**Re: Agnico Eagle's response to CIRNAC Comments regarding the Whale Tail (2AM-WTP1830) –60-Day Notice
Whale Tail Emulsion Plant**

- Crown-Indigenous Relations and Northern Affairs Canada – December 20, 2021: Crown-Indigenous Relations and Northern Affairs Canada's (CIRNAC's) Review of the Commission and Construction of Whale Tail Emulsion Plant Proposal; Submitted by Agnico Eagle Mines (AEM) for Type A Water Licence No. 2AM-WTP1830

TITRE / TITLE
AGNICO EAGLE - DIVISION AMAL
446 - EMULSION PLANT PA
230 - GENERAL EARTHWORKS
DETAIL AND SECTIONS

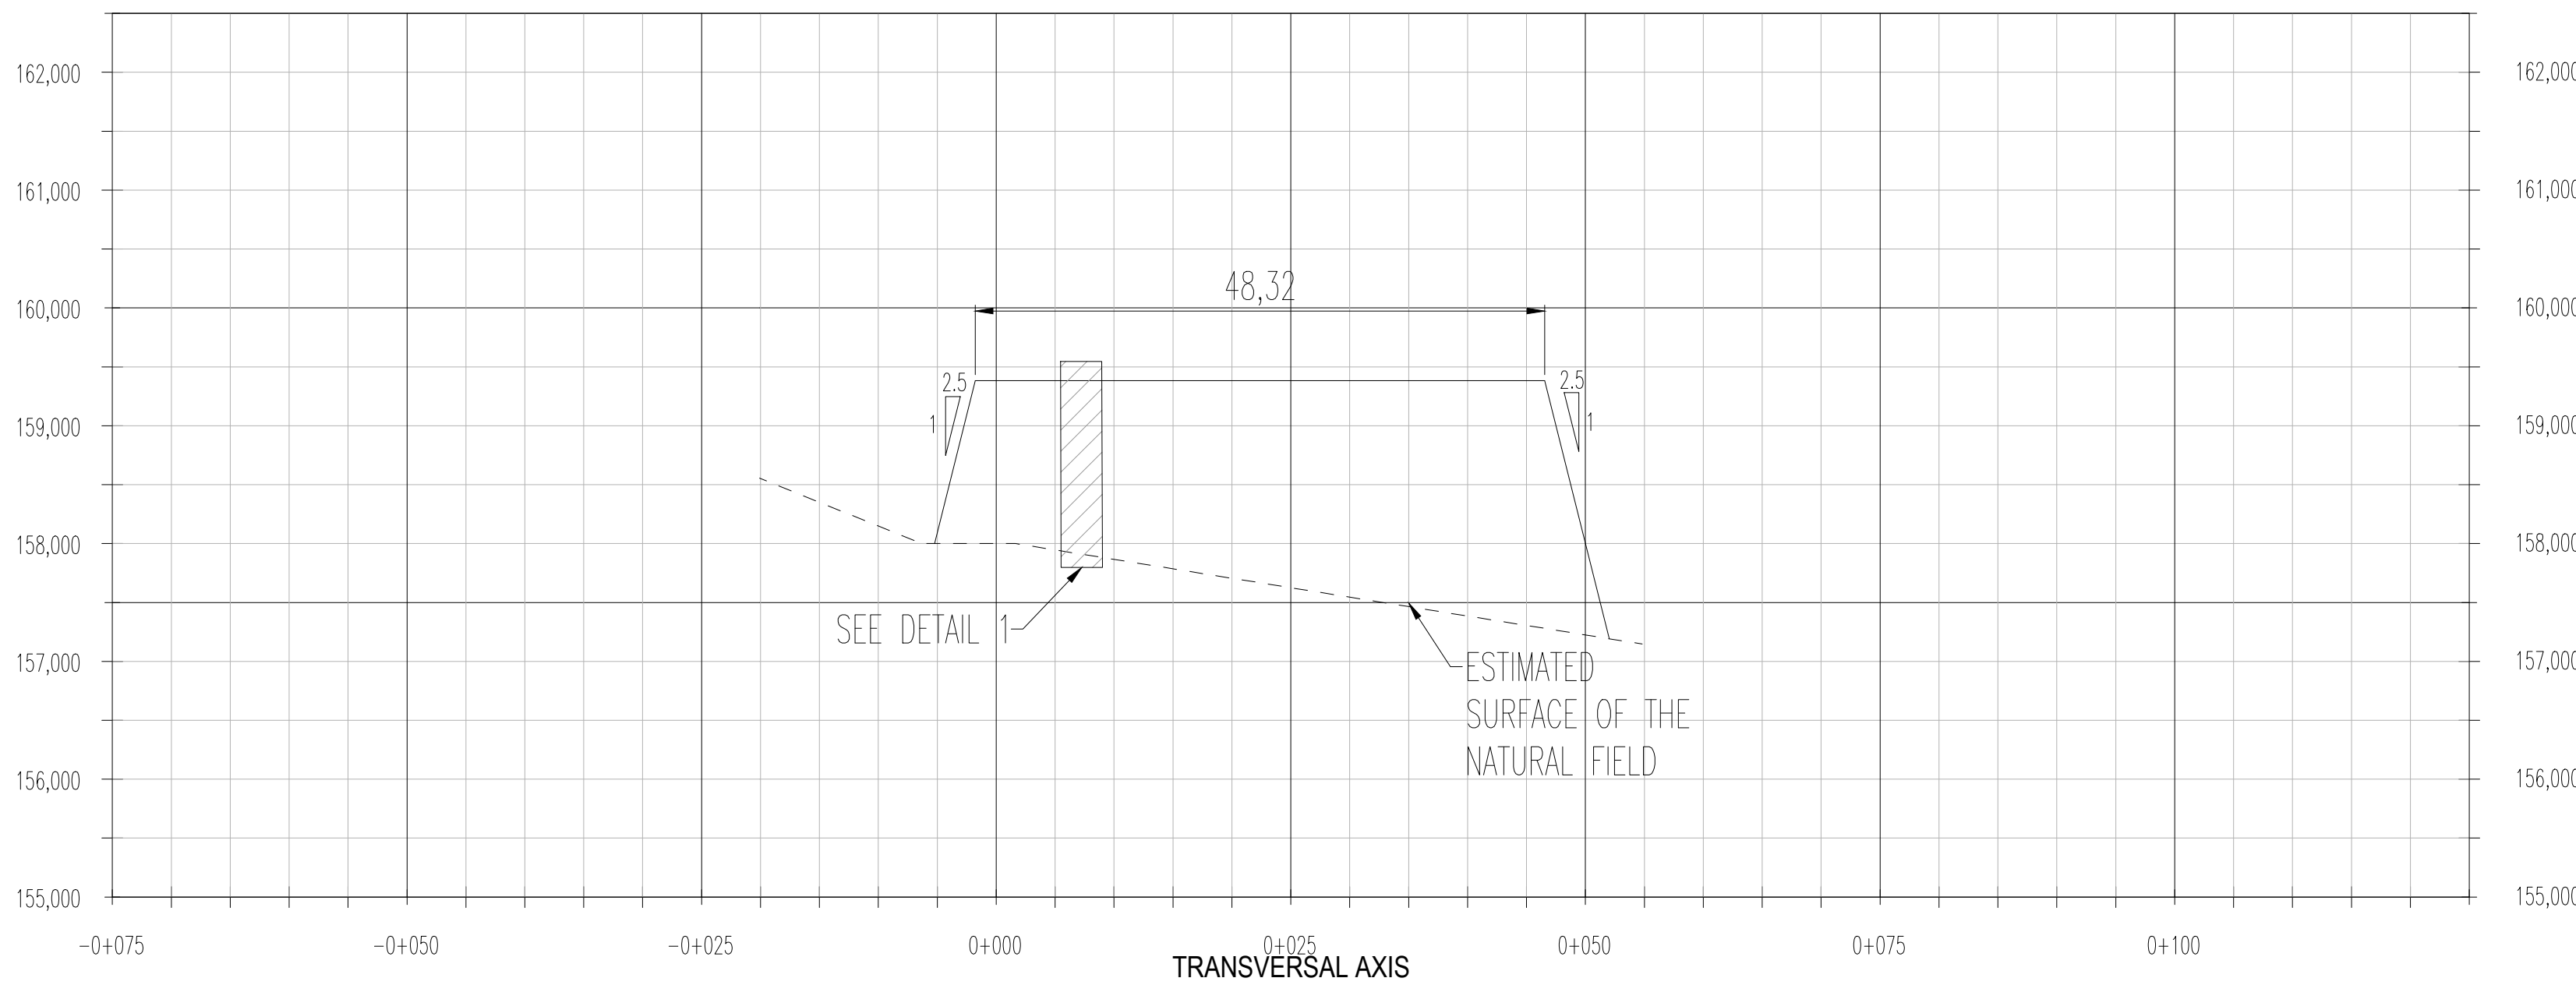
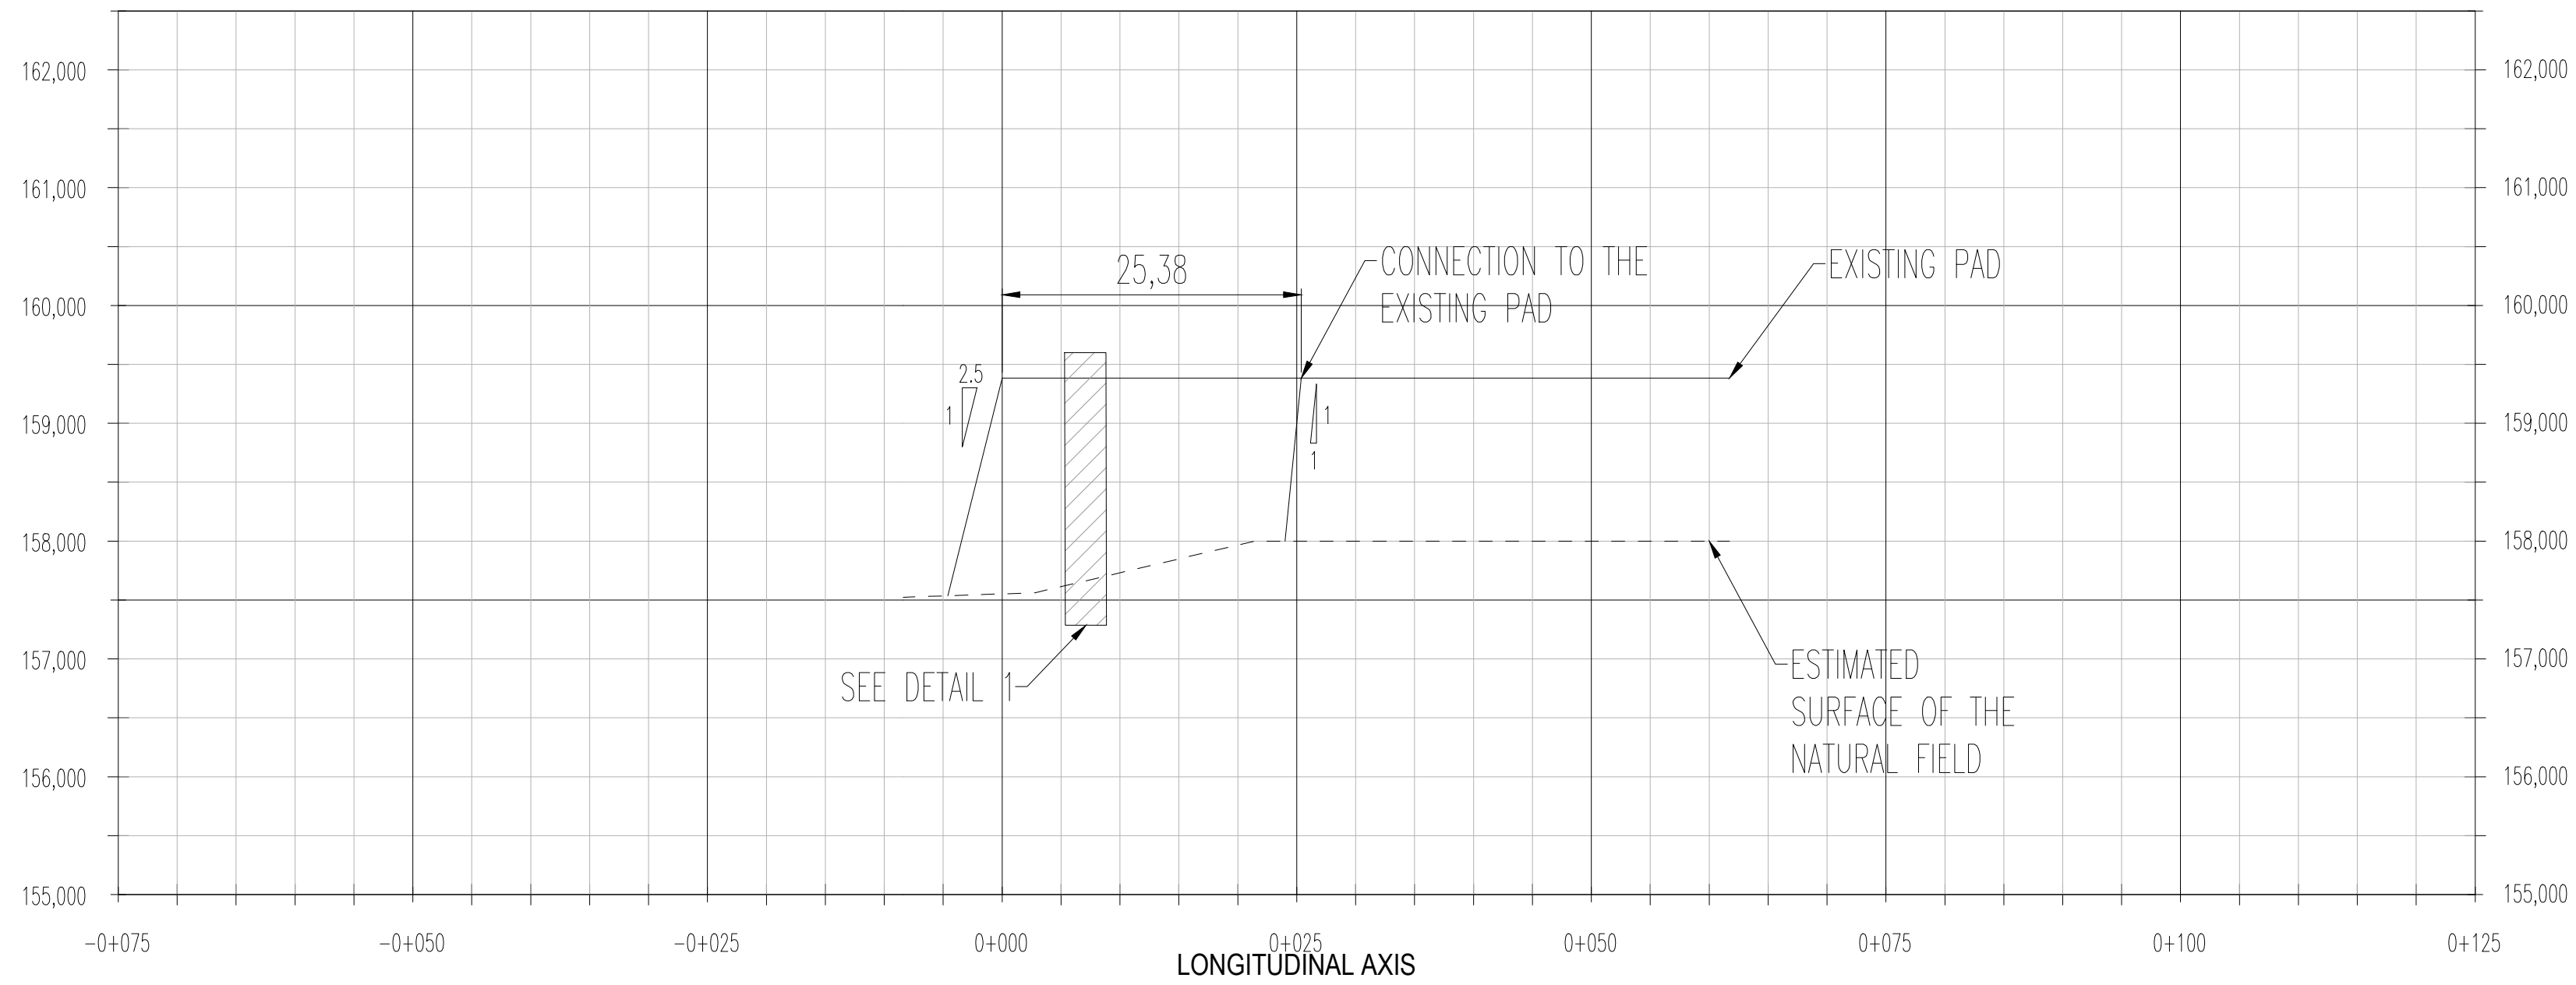
Comment: CIRNAC is not sure how AEM plans to put in place all the indicated fill materials for berm and anchor trenches (e.g. compaction lift thickness, soil compaction, machinery etc.). Also, CIRNAC identified that AEM did not provide specifications for the engineered fills indicated in the drawings and does not know how AEM plans to protect the ground water in the Emulsion Plant against contamination.

- Specifications for engineered fills indicated in the attached drawings to AEM's notification letter to the NWB

Minimum placement specifications for the engineered fills indicated in the drawings are located on 61-446-230-003 "446-Emulsion Plant Pad, 230-General Earthworks Detail and Sections", sealed by WSP July 22, 2021.
